**SITE PLAN REVIEW SHEET
ENVIRONMENTAL VARIANCE REQUEST ONLY**

CASE: SP-2021-0169D

PROJECT NAME: Crossroads Logistics Center Additions

The applicant is requesting to vary from LDC 25-8-342 to allow fill over 4-feet up to 17-feet.

CROSSROADS LOGISTICS CENTER ADDITIONS
CUT AND FILL EXHIBIT
8508 E. PARMER LANE
AUSTIN, TEXAS 78653

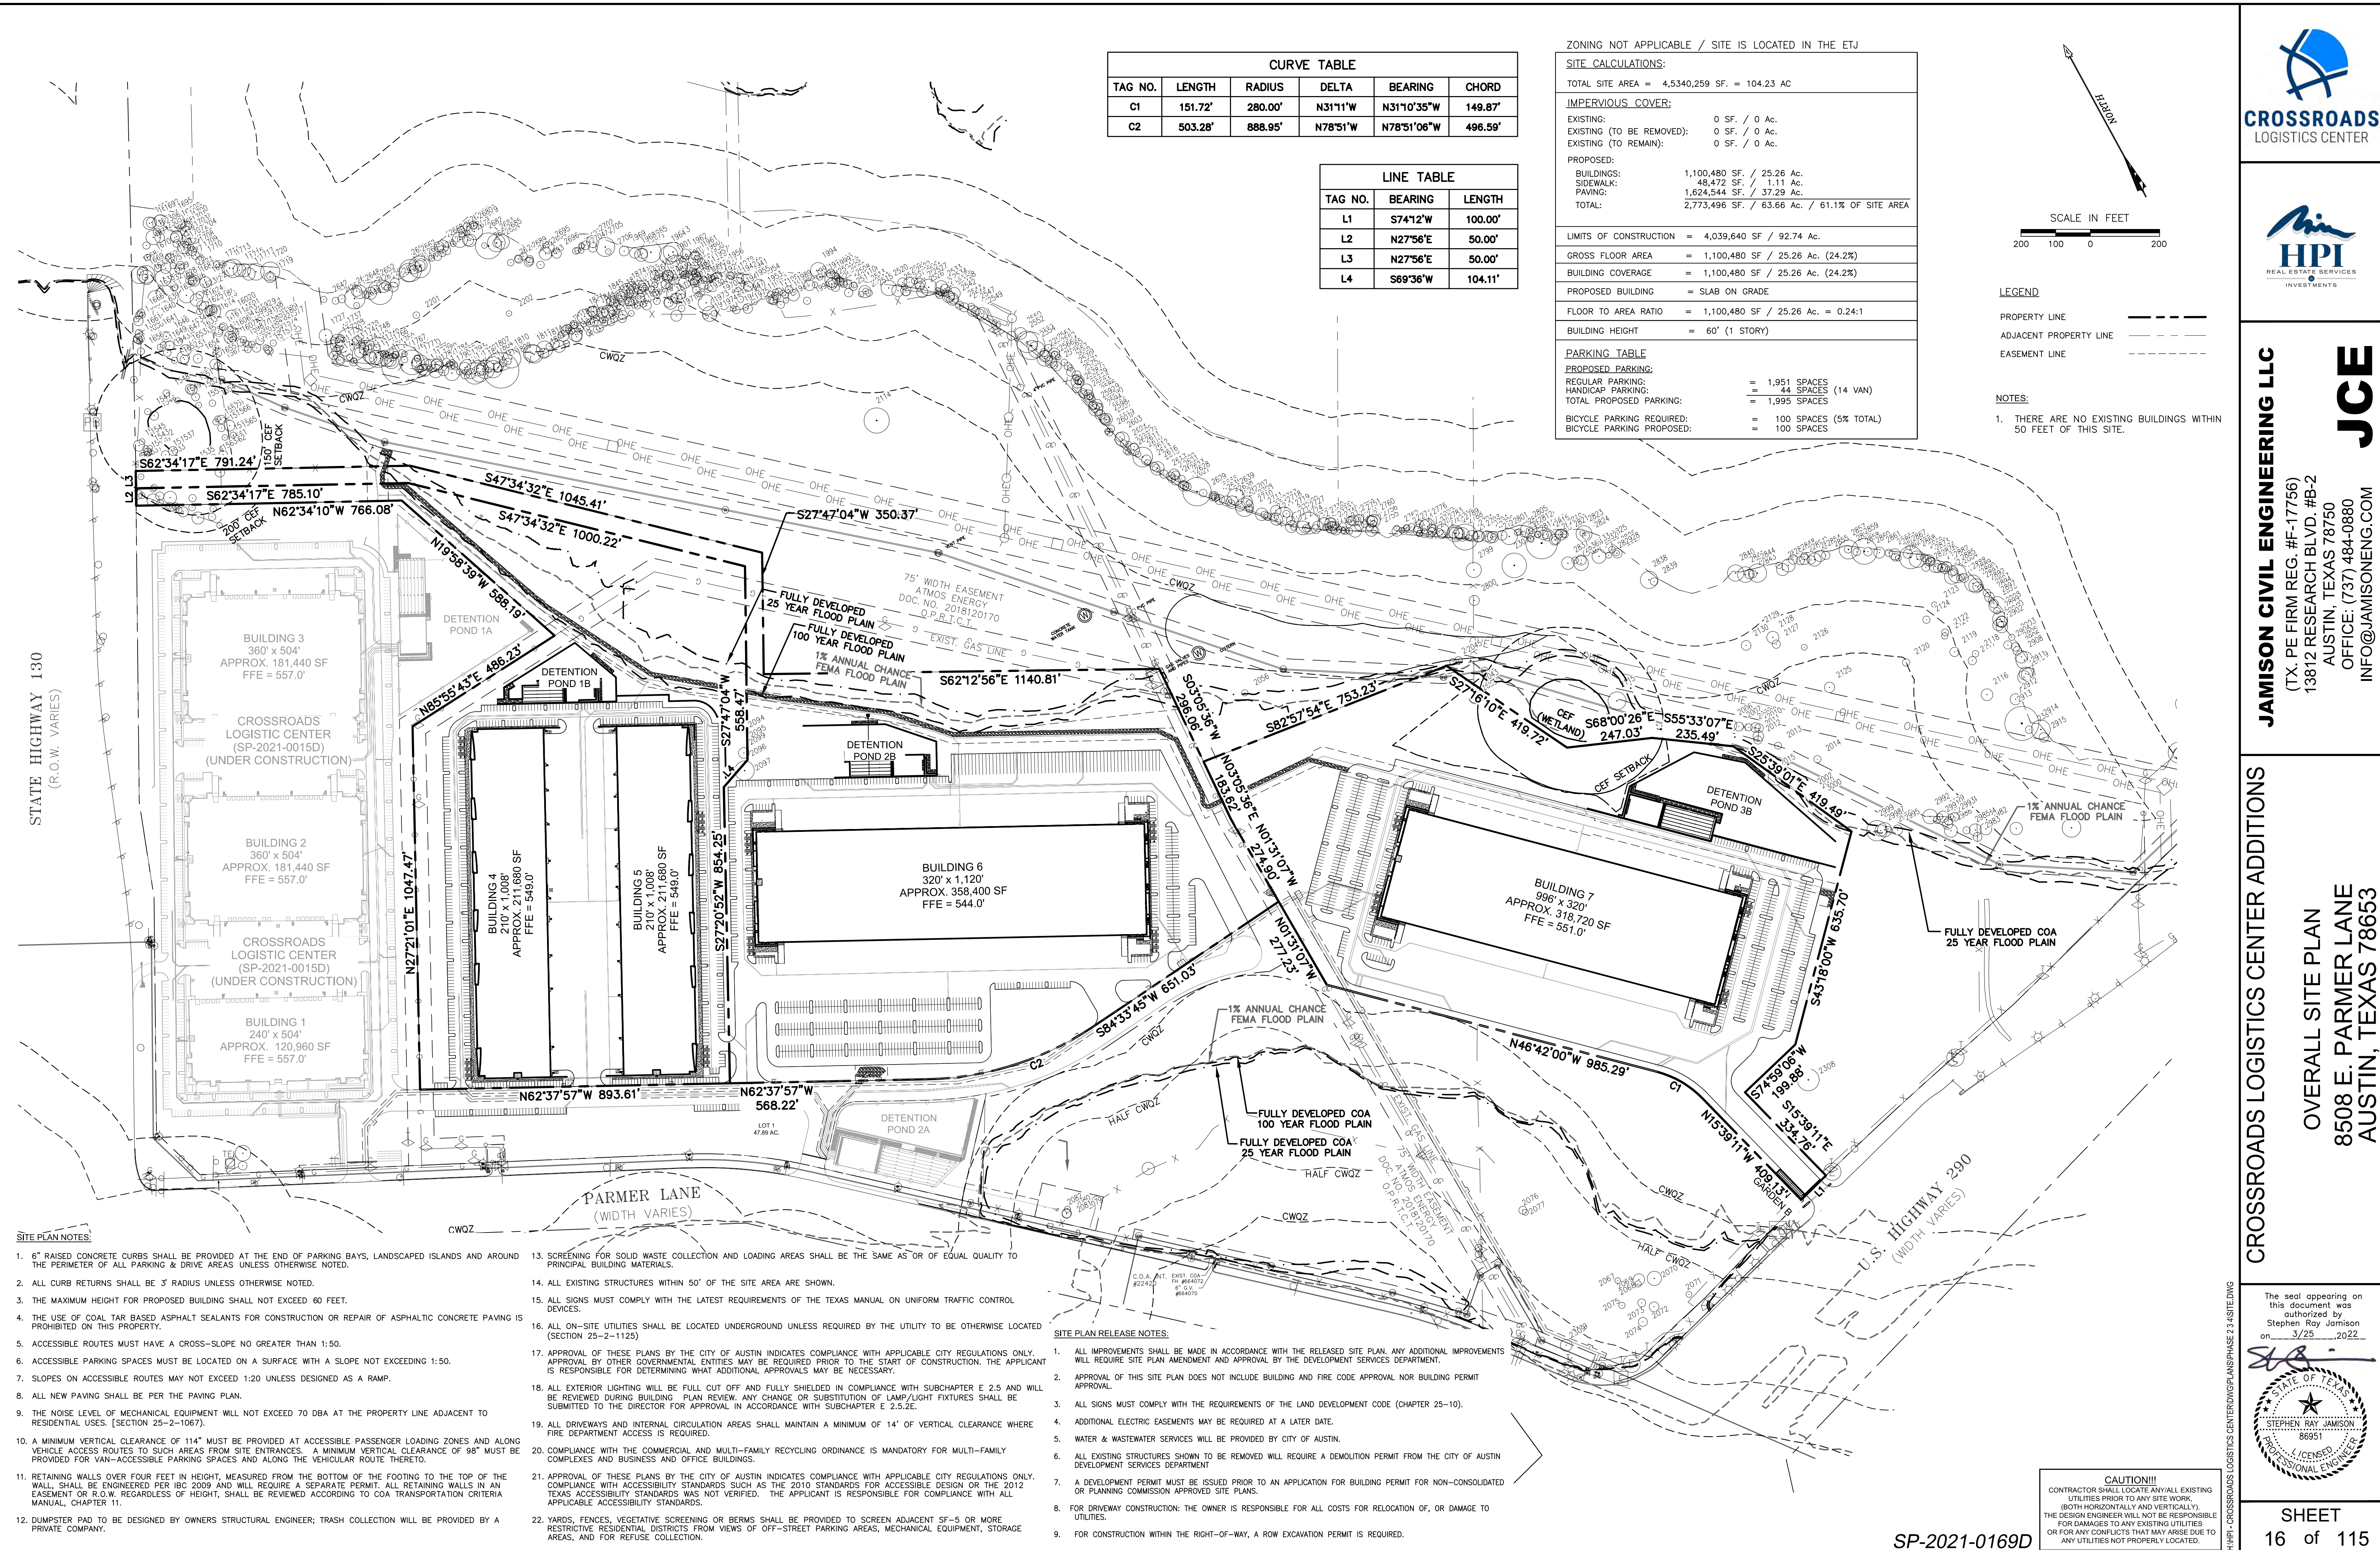
The limits of the fill do extend beyond the building as shown in the cut/fill exhibit but is contained with a retaining wall structure designed in conjunction with the building walls, so the building is supported. Prior projects in this industrial development zone had a similar situation. A prime example is Park 183 Buildings 6 & 7, SP-2021-0072C. A Land Use Commission variance was granted to LDC 25-8-342 to allow cut and fill up to 17 feet.

- Increase setback area by a minimum of 1.09 acre for existing CEF.
- Preserve trees/natural areas.
- Apply City of Austin Landscaping Ordinance on ETJ site.
- Increase tree inches on site/mitigation.
- Provide structural containment of fill with a retaining wall.
